Clause 83 Summary

IEEE P802.3ba

November 2008 Dallas

Comment 383 resolution

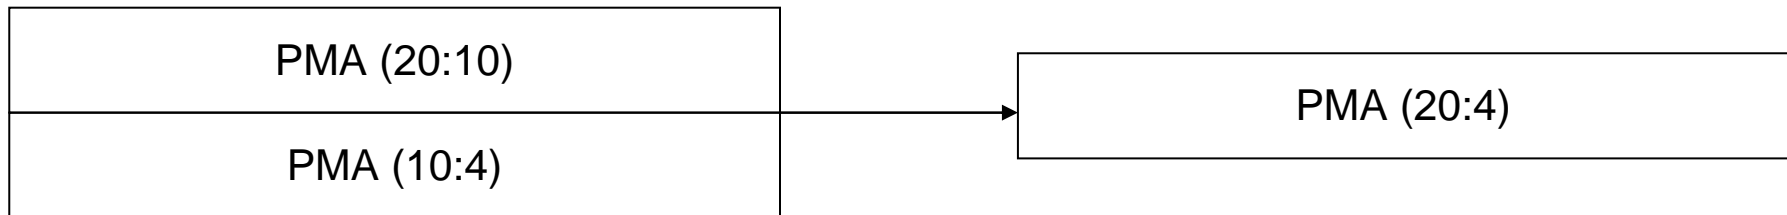
For 40GBASE-R, the number of input and output lanes are divisors of 4 and
or 100GBASE-R, the number of input and output lanes are divisors of 20

Since the interfaces are abstract when there is not a physical instantiation, we don't need to draw adjacent PMA stages when there is not a physically instantiation of the interface between them
